TOWN OF ACTON
472 Main Street
Acton, Massachusetts, 01720
Telephone (978) 264-9628
Fax (978) 264-9630

INTERDEPARTMENTAL COMMUNICATION

Subject: Keyspan Energy, Cathodic Protection Work Request

Figure 4 - UP #49-23 on School St at Piper Rd

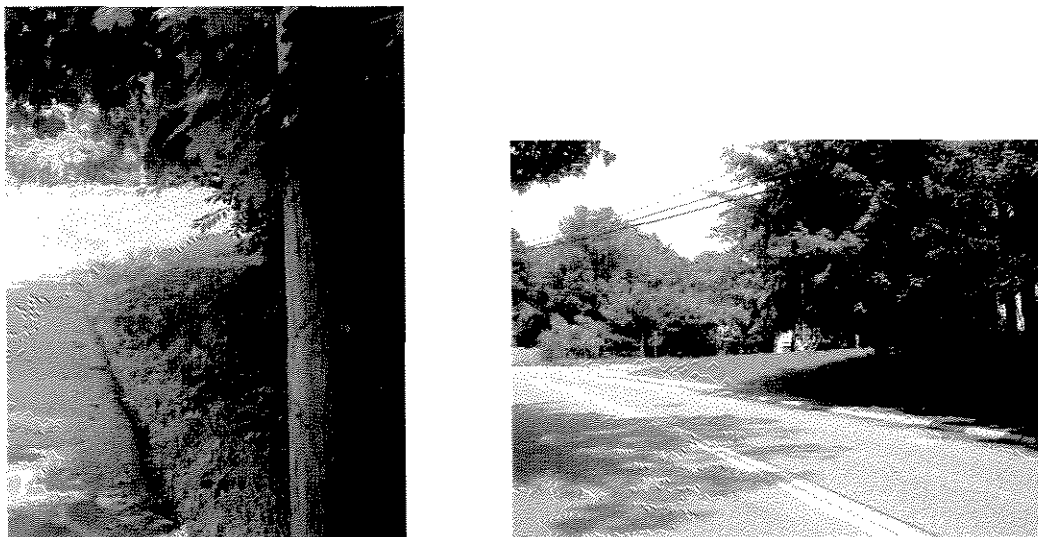
- The proposed post and the utility boxes need to be installed as close to the wall as possible to prevent the proposed unit from overhanging the existing sidewalk. We want to prevent any injuries to pedestrians and bicyclists as well as potential damage caused by the sidewalk plows during the winter months.
- There is an existing stone bound that mark the sideline of School Street by Piper Road that is located close to the proposed work. We have enclosed a photocopy of the sidewalk plan for School Street from 1995 that shows this survey marker by Piper Road. If this bound is disturbed during the construction, Keyspan should be required to hire a registered land surveyor to reset and certify the new bound location.

Figure 5 - UP #137-4 - Country Club Rd - between house #5 & #9

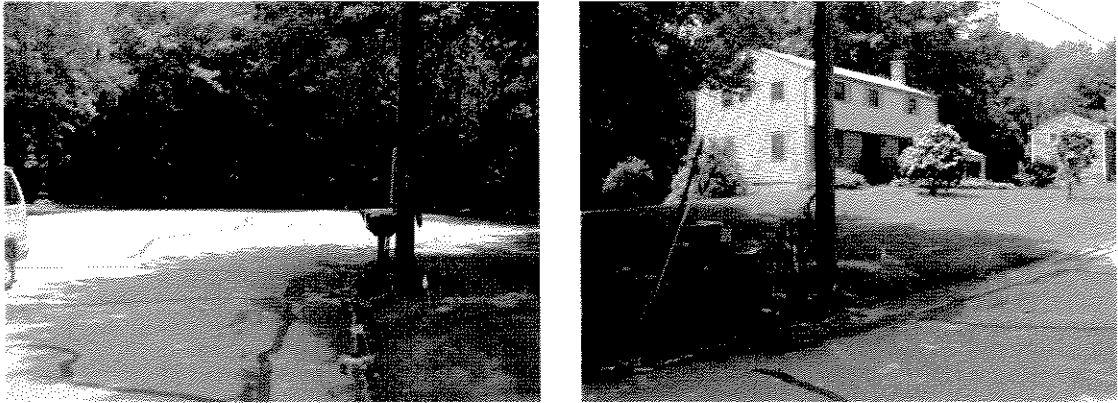
- There is an existing concrete bound that marks the sideline of Country Club Road adjacent to the driveway for house #9. We have enclosed a photocopy of the recorded plan of land for #5 & #9 Country Club Road (Registry Plan #461 of 1990). If this bound is disturbed during the construction, Keyspan should be required to hire a registered land surveyor to reset and certify the new bound location.

Figure 6 - UP #6 - Wood Lane - between house #41 & #49

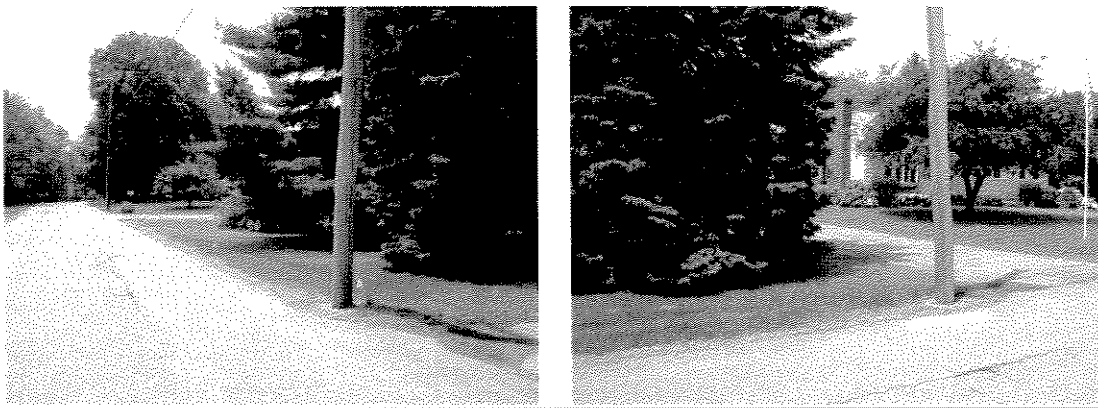
- The proposed work appears to be located across the frontage of a 40' wide strip of town –owned conservation land attached to the Arboretum.
